MEMORANDUM

SUBJECT: Site Plan Approval Amendment – 111 Breen Avenue

RE: Pete's Trattoria Parking Lot Expansion Site Plan Approval Comment Response Letter
Tax Map P.N. 8-01-214.100 (Pete's Trattoria)
111 Breen Avenue, City of Watertown, New York

SITE AND LANDSCAPING PLAN PETE'S TRATTORIA PARKING LOT EXPANSION

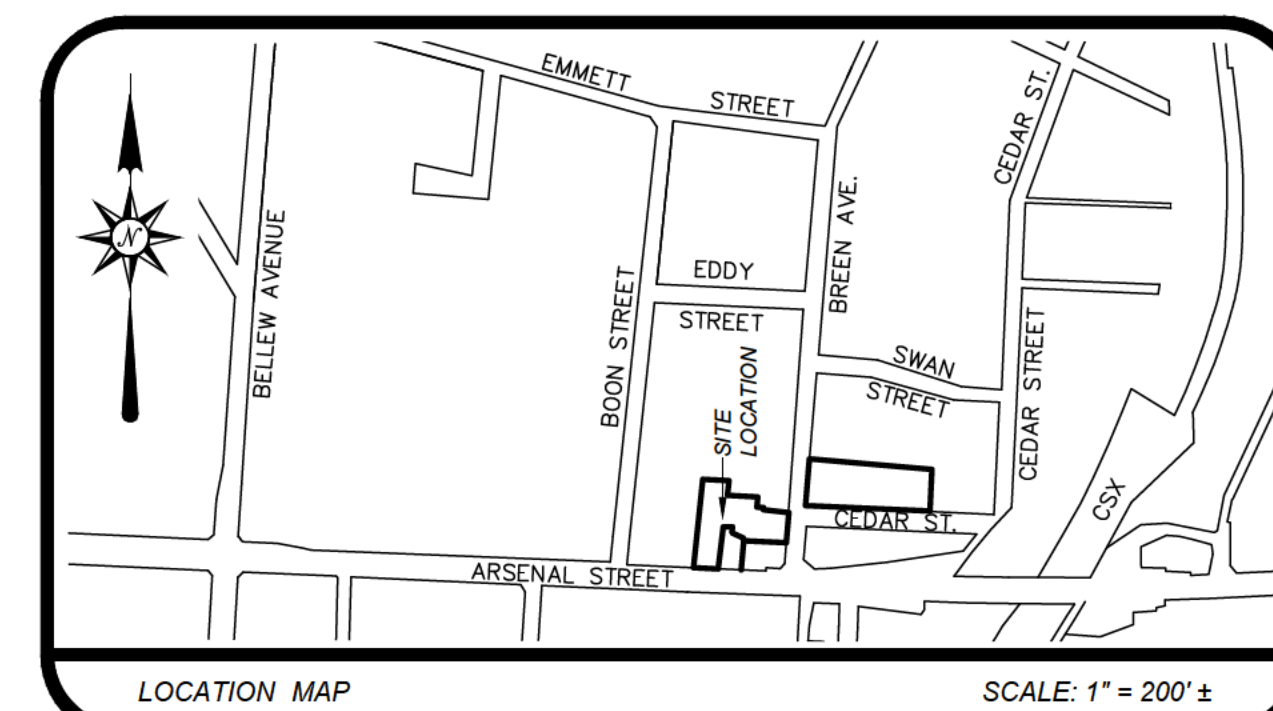
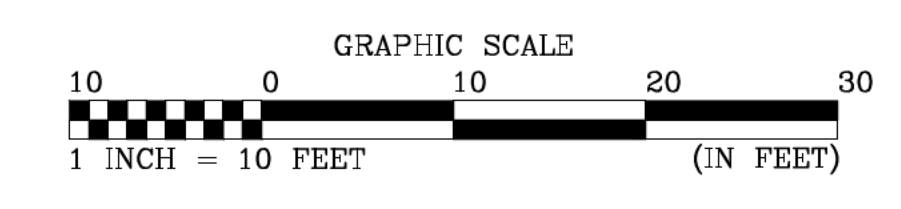
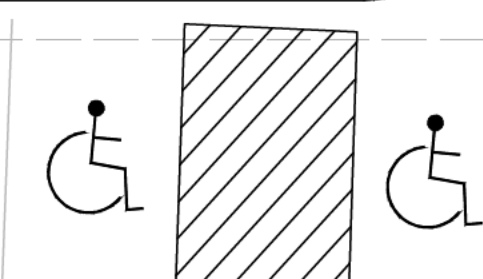
2. The applicant shall provide a lot coverage calculation on the Planning Data table on Sheet C101.

4. The applicant shall revise the landscaping plan to conform to the requirements of Section 310-83 of the Zoning Ordinance.

Concur. A lot coverage calculation has been added to C101. The proposed lot coverage exceeds the allotted 70% coverage. An area variance will be submitted to support this effort.

Concur with City Comments. Two large deciduous trees have been added to the frontage of the project site. See C101 for additional landscaping.

UTILITY AND GRADING PLAN PETE'S TRATTORIA PARKING LOT EXPANSION

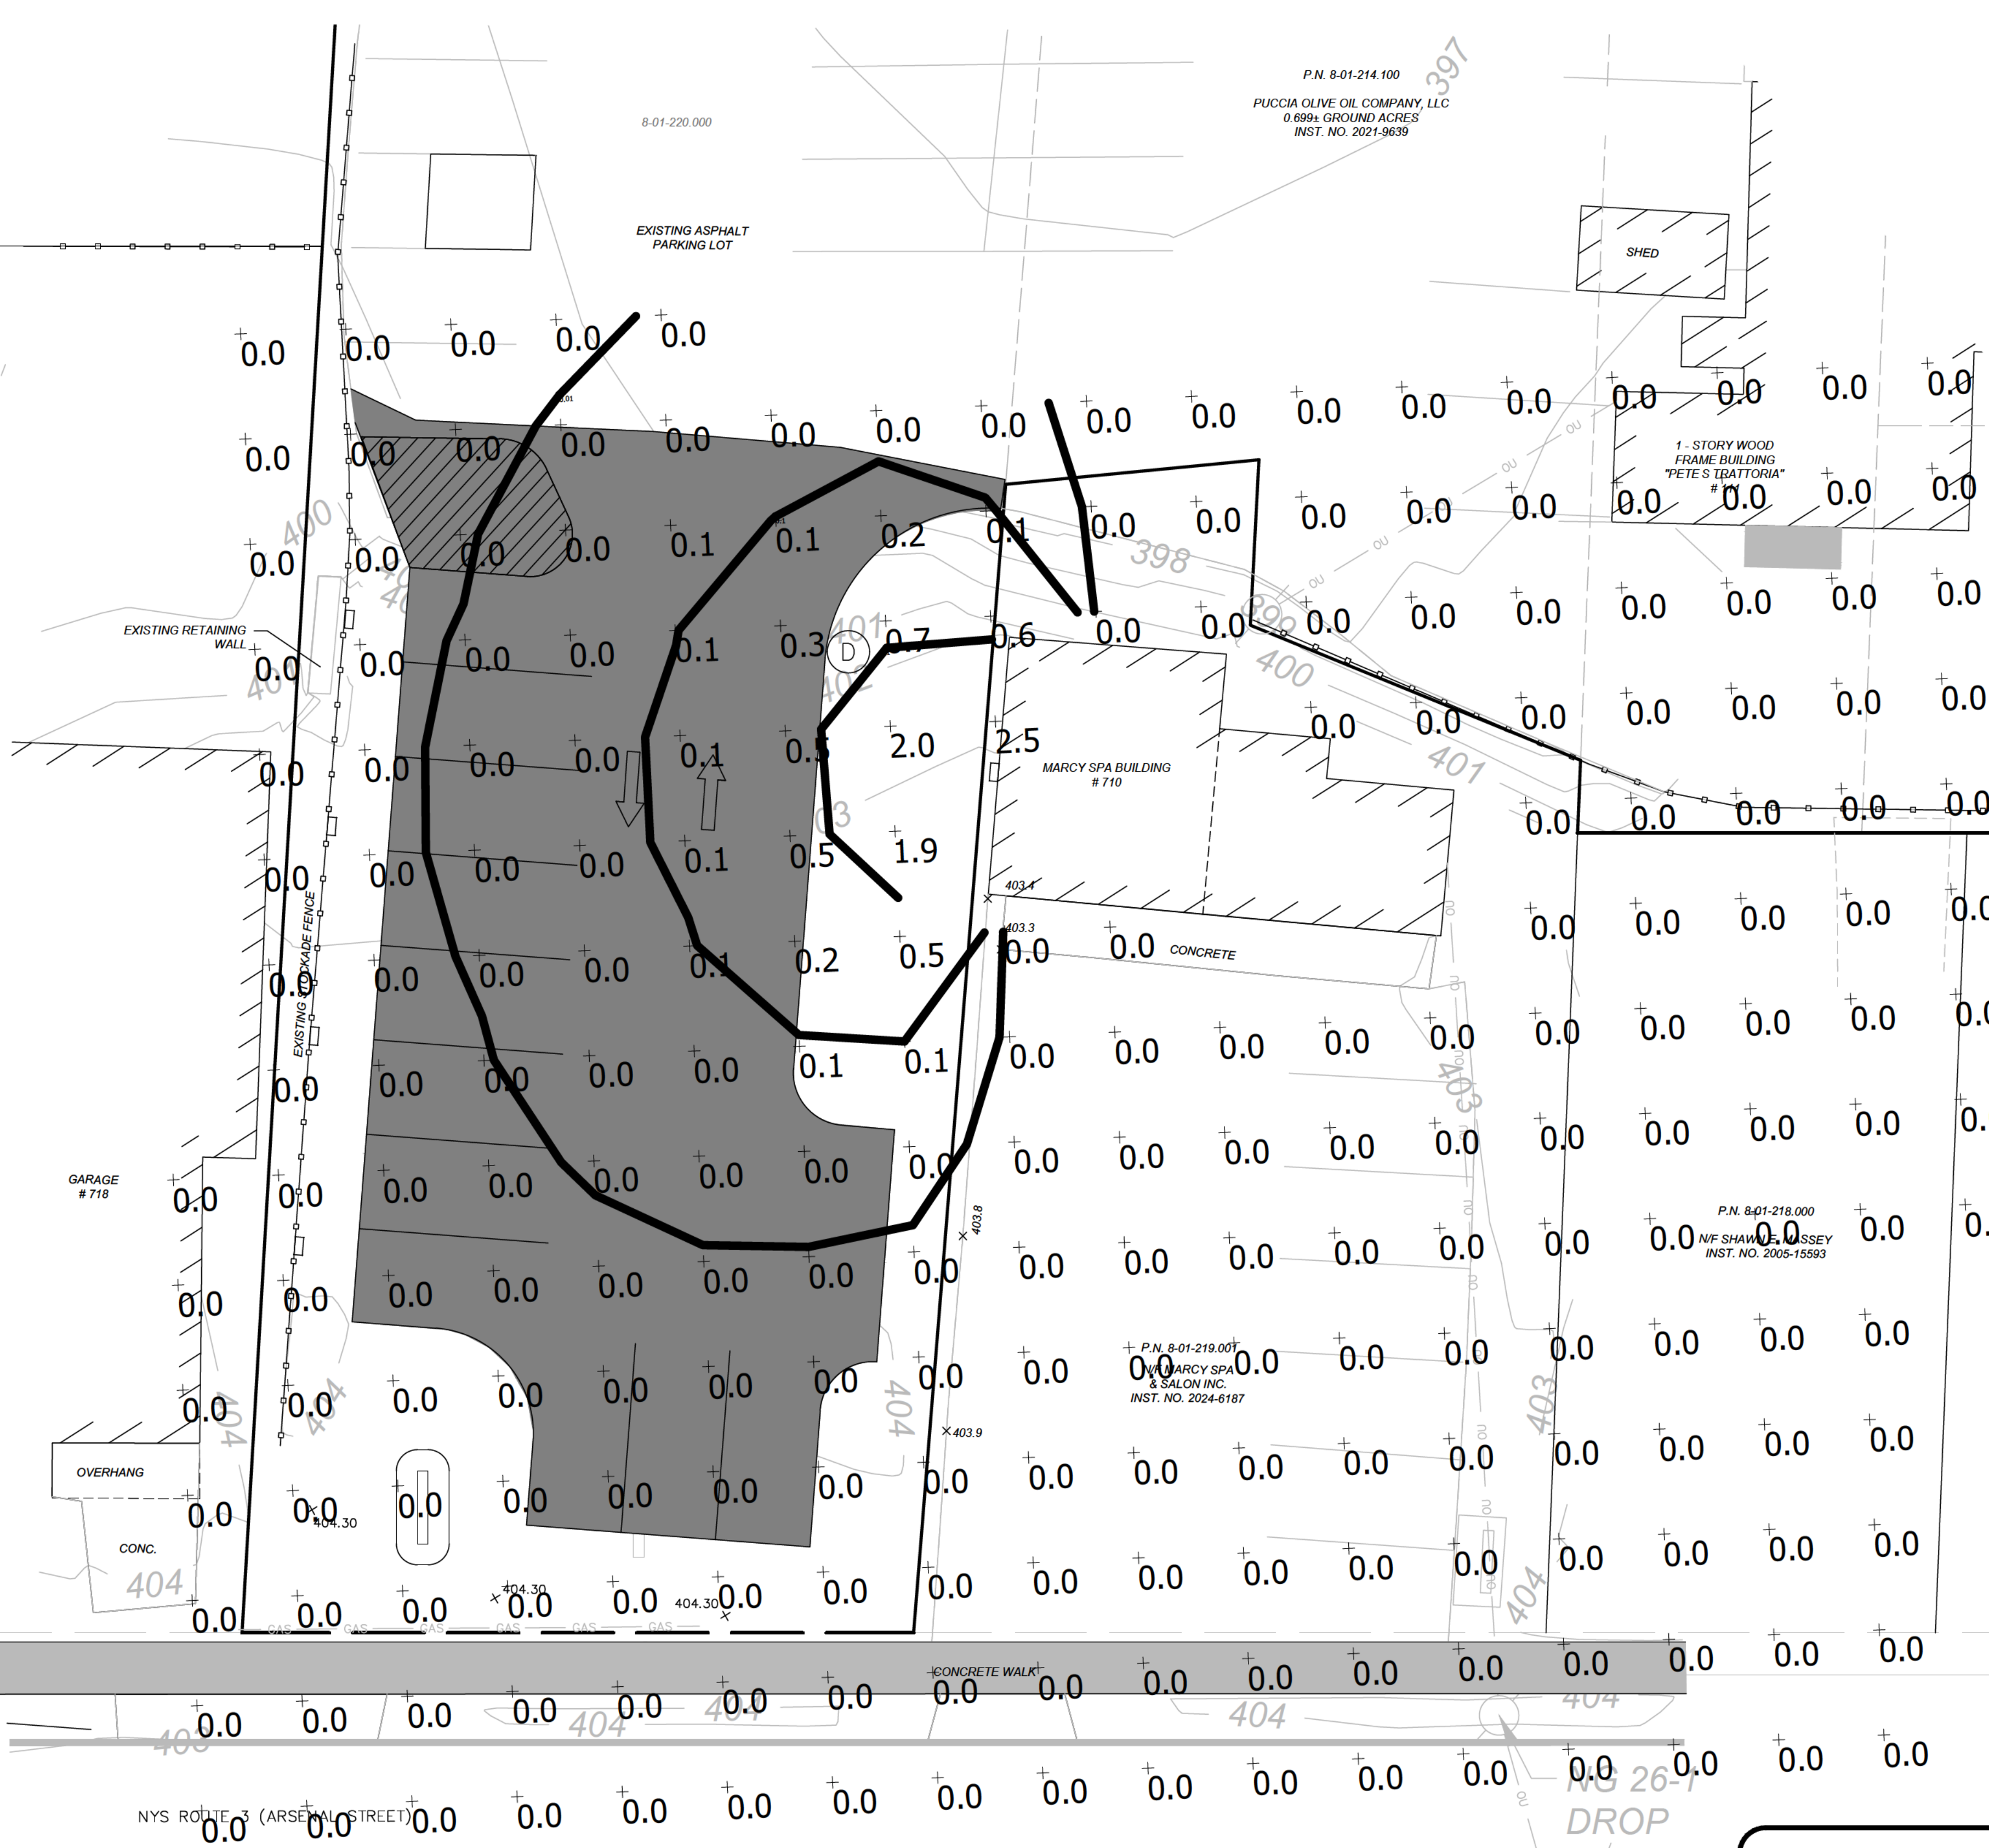
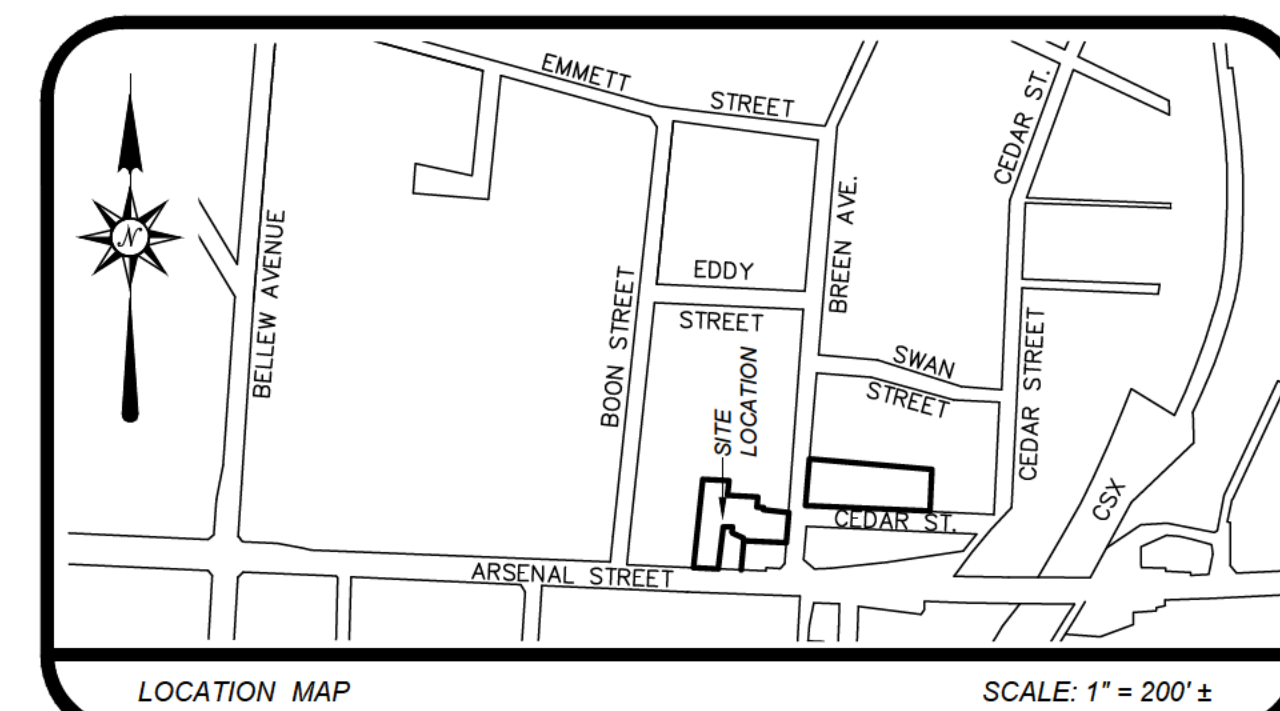
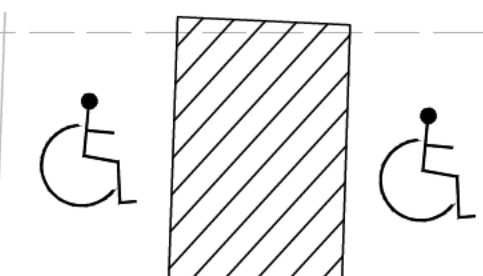
Grading, Drainage and Utilities: The applicant has added all dry well drainage infrastructure to the C102 drawing, with a note identifying a 4' diameter and a 10' depth. The previous Site Plan Approval required the applicant to submit pre-and-post construction stormwater drainage calculations to the City Engineering Department. This should remain a condition of the amended Site Plan Approval.

5. The applicant shall add all dry well drainage infrastructure to the C102 drawing and submit pre-and-post construction stormwater drainage calculations to the City Engineering Department.

Concur. Dry well information and location are shown on C102. Dry well detail is Detail 8 on C501. The areas contributing to the existing dry well in the existing parking and the proposed drywell, in conjunction with the quality, pervious soils in the project area present little to no concern for storm water leaving the project parcel.

PHOTOMETRICS PLAN PETE'S TRATTORIA PARKING LOT EXPANSION

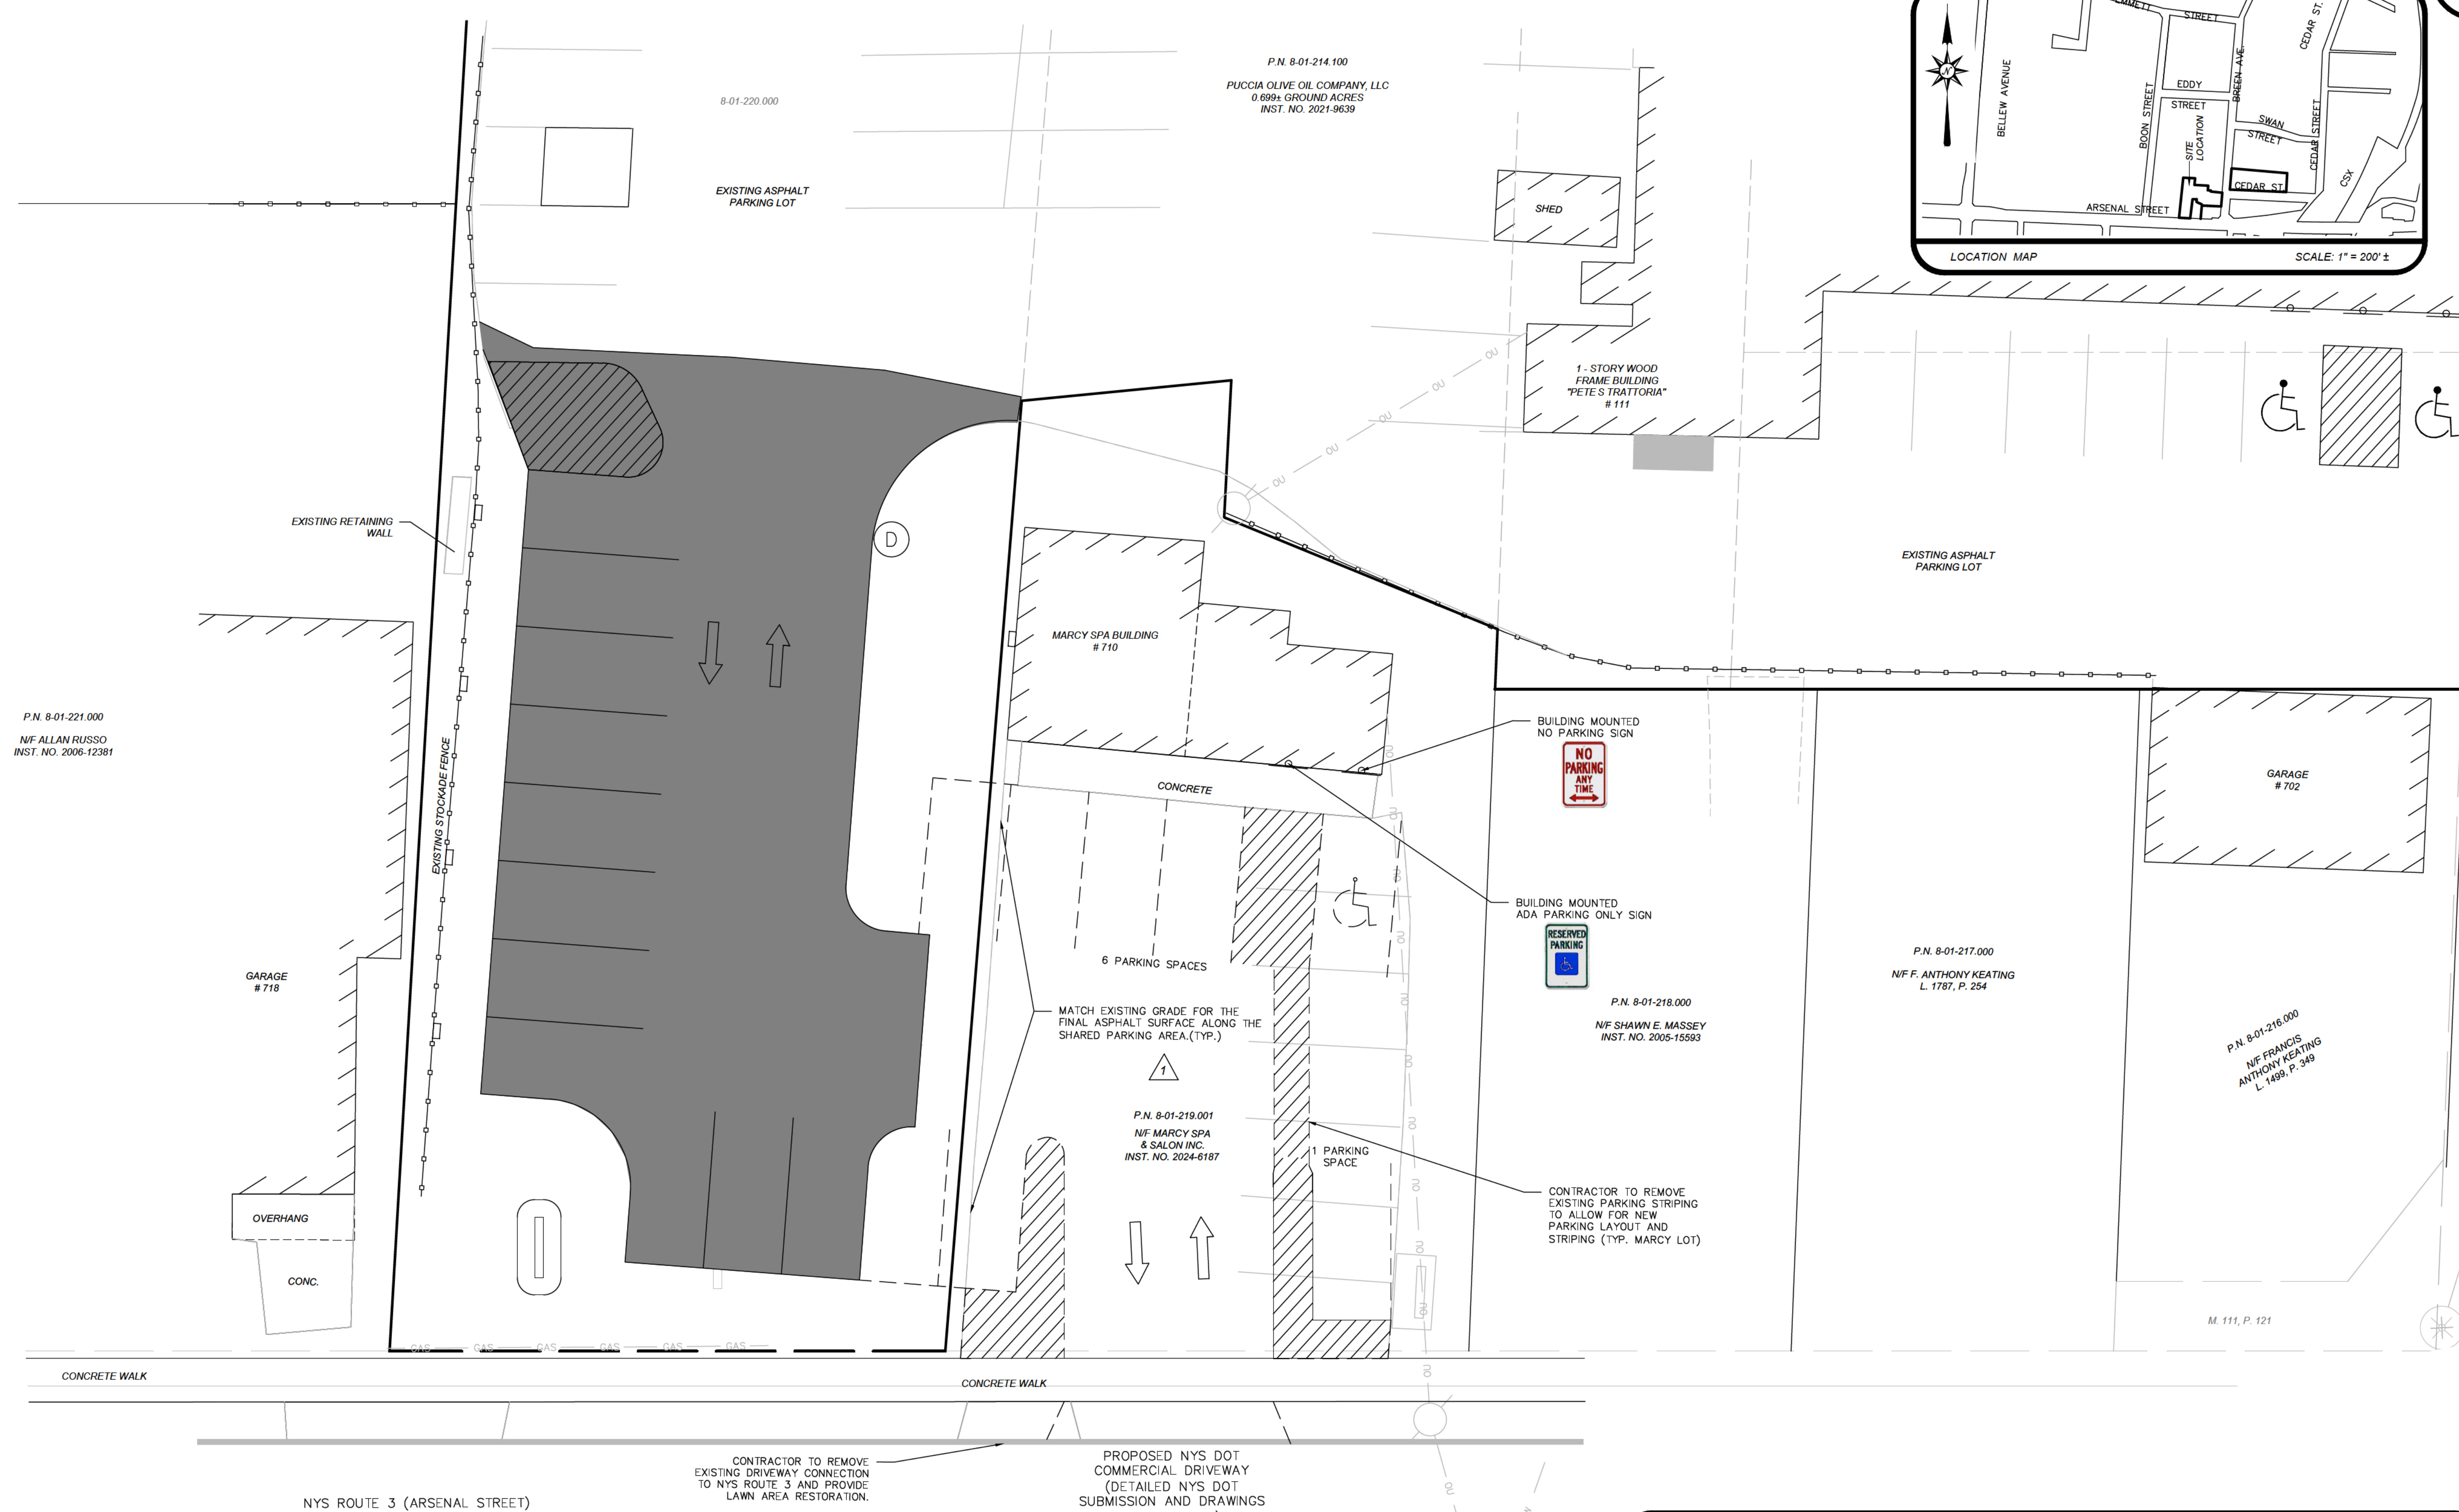
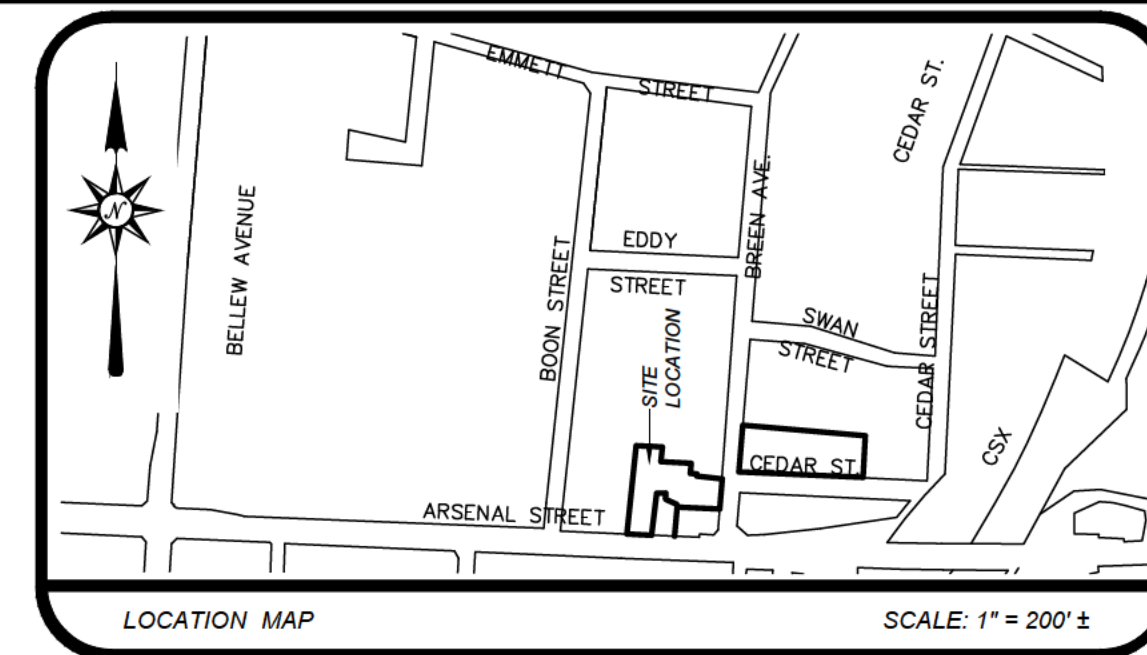
Lighting: The applicant has submitted a Photometric Plan that only includes the wall pack calculation points and depicts 0.0 footcandles for the rest of the parking lot. The applicant states that lights mounted below the existing fencing will be dark sky compliant will and not cause spillage across the western property line.

6. The applicant shall submit proof that the light spillage across the western property line is under 0.25 footcandles, as the adjacent property is a residential use.

Concur. C103 Photometrics Plan has been added to the drawing set. The wall pack calculation points area shown. Note that with the solar lighting proposed, photometrics are not fully established. The lights will be mounted 2' below the top of the existing fencing and be dark sky compliant. Light Spillage is not anticipated with the proposed photometrics from the site.
